CITY OF SUNNYVALE REPORT
ADMINISTRATIVE HEARING

File Number: 2009-0931 **Permit Type:** Special Development Permit

Location: 923 W. El Camino Real (near S. Mary Ave.) (165-01-035)

Project Description: To allow a new 7,901 square foot building for an automobile dealership with an associated service use and second floor storage area.

SHEET TITLE
ARCHITECTURAL SITE PLAN

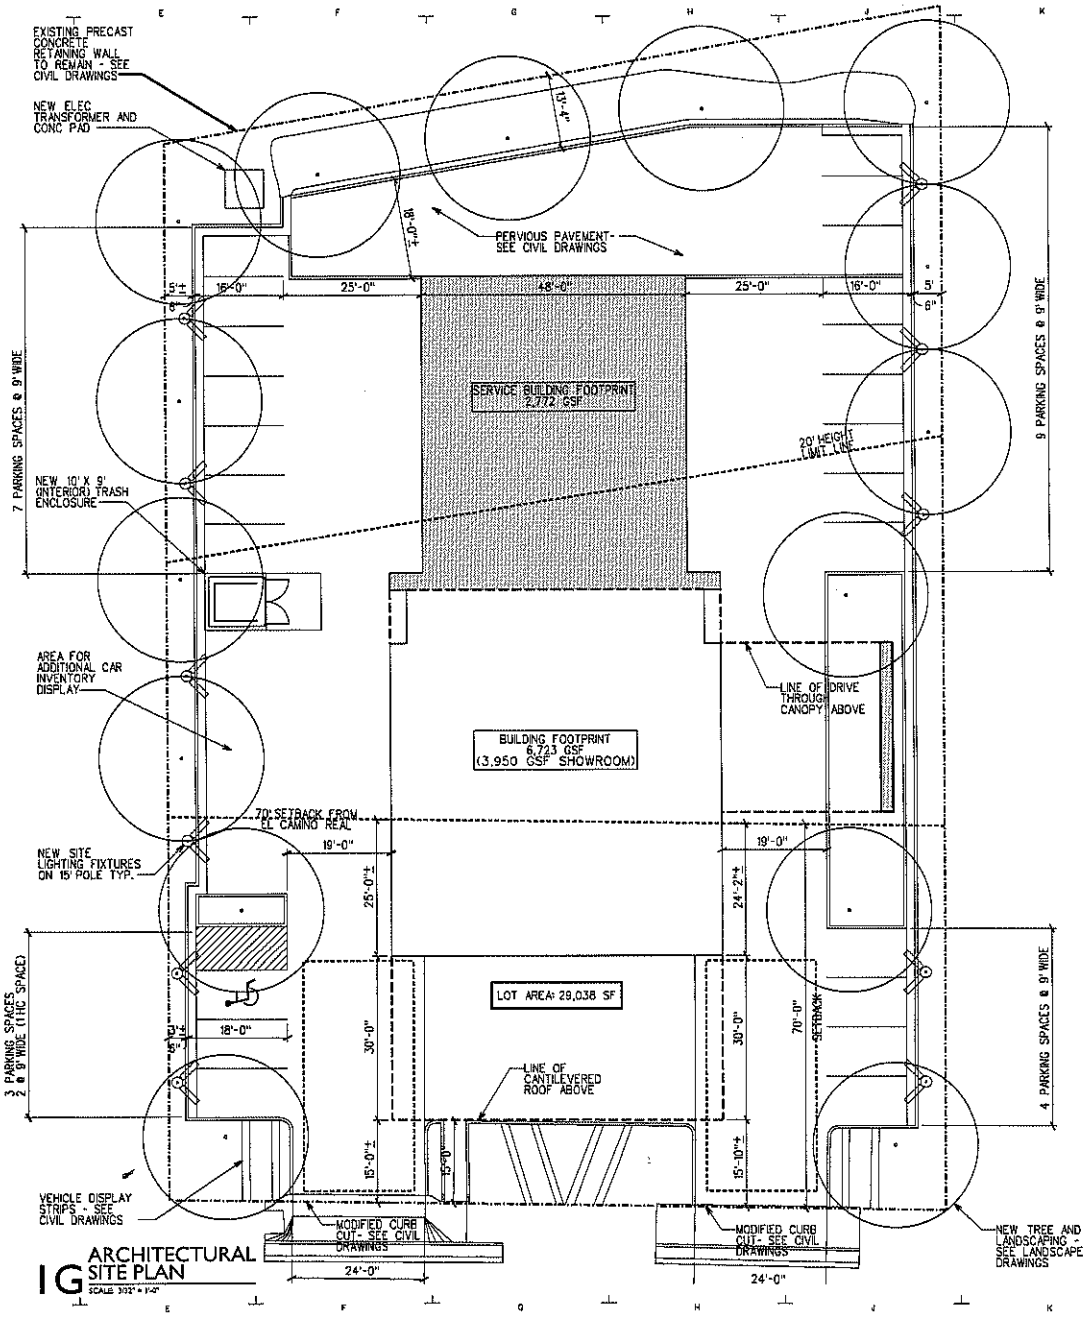
The site does not meet the required drive aisle width/back-up space for commercial uses with only 25 feet provided where 26 feet is required. Staff has worked with the applicant to ensure that adequate landscaping is provided on site. Previous designs were modified to increase perimeter landscaping to meet total landscaping standards. In combination with the need for adequate parking and circulation around the building, the drive aisle width has been slightly decreased. As shown on the site plan, drive aisle widths are further reduced where no parking is adjacently positioned; this configuration is permitted by Municipal Code.

Based on the amount of parking spaces, an additional accessible space is required. Condition of Approval #7E required modifications to the site plan to include one more additional space for a total of two. Per VTA guidelines, one Class I bicycle space per 30 employees is required. Condition of Approval #7G requires 1 bicycle locker be provided for employees.

E. One additional handicap accessible space shall be provided for a total of two.

SHEET TITLE
TREE SHADING PLAN

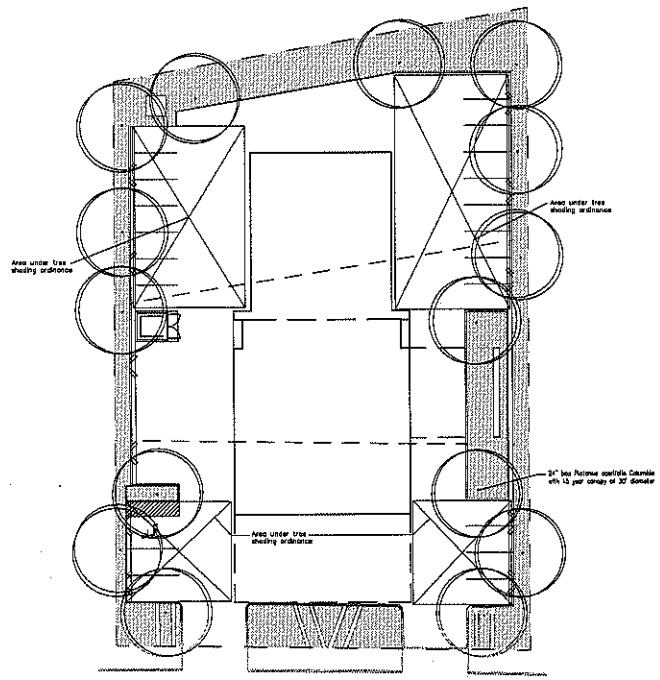
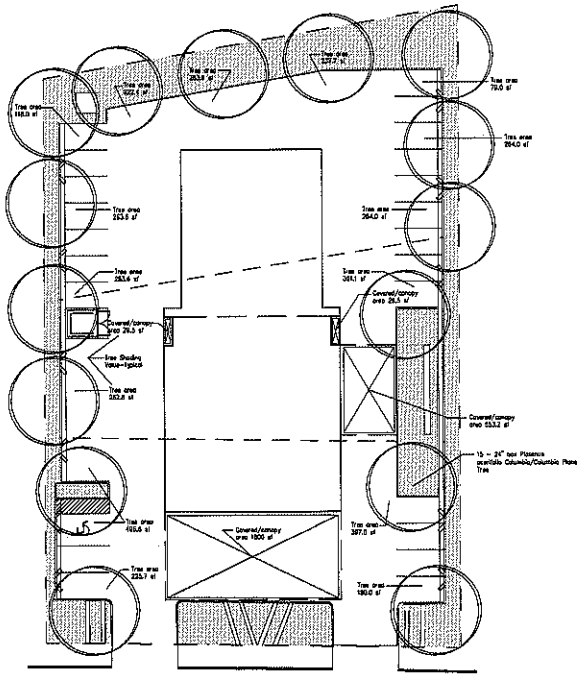
The plans indicate that the requirement for 50% shading for parking areas within 15 years will not be met. The applicant has provided an analysis which is included on Page 2 of Attachment B. A second analysis was provided which indicates a higher percentage of shading (approximately 40%), which takes into account canopy area over areas not adjacent to parking spaces.

The proposed development also would not meet the required 50% shading within 15 years as stated earlier in the report. Provided plans indicate that the development would achieve 32% shading. The applicant has provided an

analysis that includes all paved surfaces, including those not serving parking area, with the inclusion of architectural canopy area that covers portions of the lot. Under this calculation, 40% shading is achieved.

SHEET TITLE
ROOF PLAN

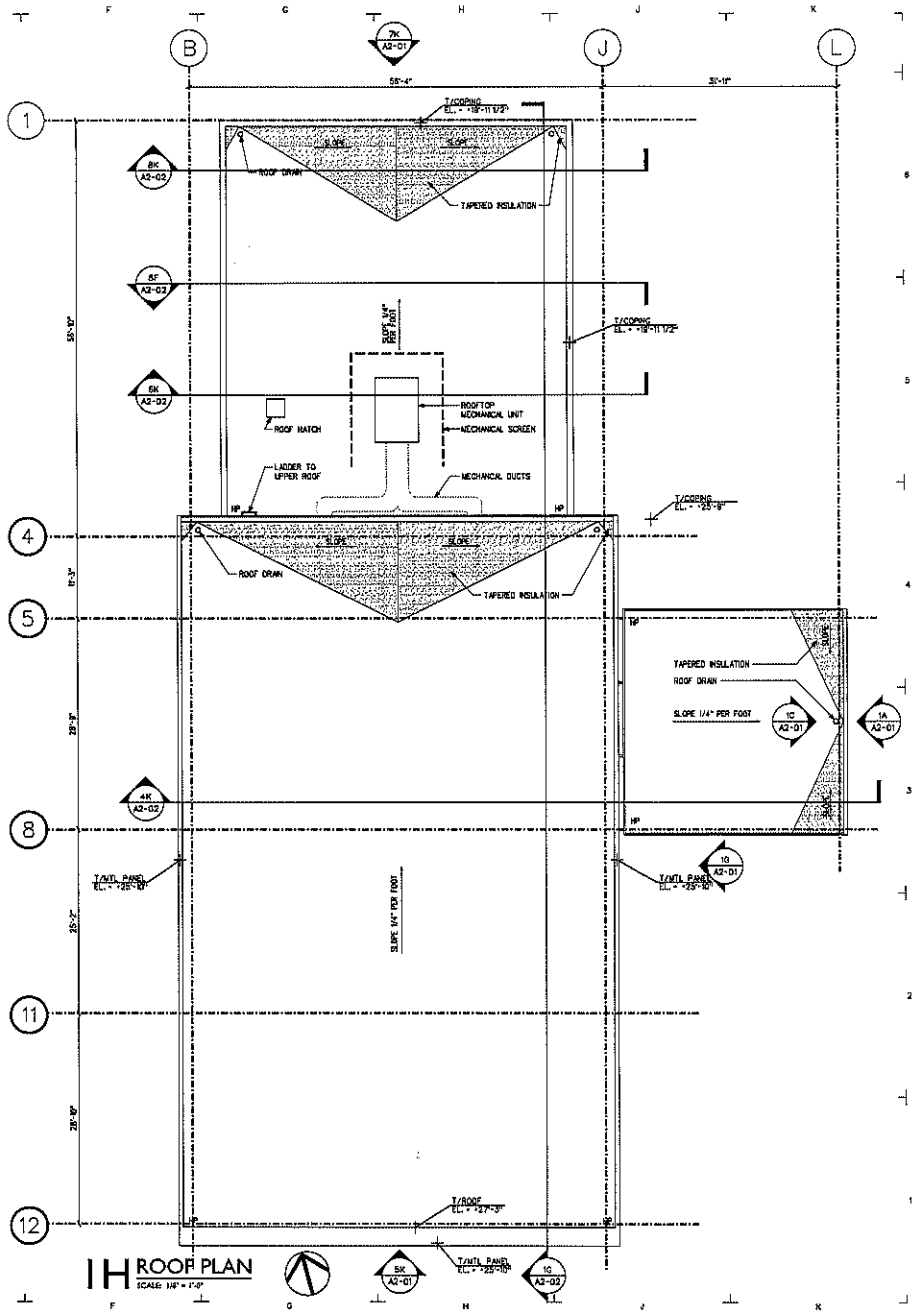
The provided plans indicate roof equipment on top of the building. Per Condition of Approval 4D, this equipment will be required to be screened to the highest point on all four sides. Proposed signs for the building will be reviewed through a separate Miscellaneous Plan permit and building permit.

C. All exterior equipment shall be completely screened to the highest point from the street and neighboring properties on all four sides.
